# Recall Bulletin 80918

Jamboree,  
Jamboree GT,  
Jamboree Sport,  
Tioga, Tioga SL,  
Tioga Ranger

**SUBJECT:**  
Repairing  
damaged  
evaporative  
emission line

**ISSUE DATE:**  
February 2009

**Figure 3**

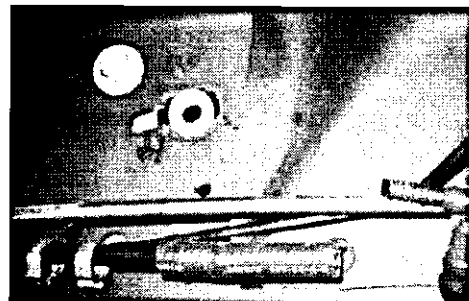
*Slide the crimp style clamps onto the steel fuel line prior to installing the new section of CARB-approved evaporative emission line.*

5. Slide the two new crimp style clamps, supplied with the Recall Kit, onto the steel fuel line, near the area being repaired. See Figure 3.
6. Push the OEM plastic line with tee forward only as necessary to facilitate installation of the new section of evaporative emission line. Next, pull the OEM plastic line with tee rearward while simultaneously sliding the hose onto the tee.
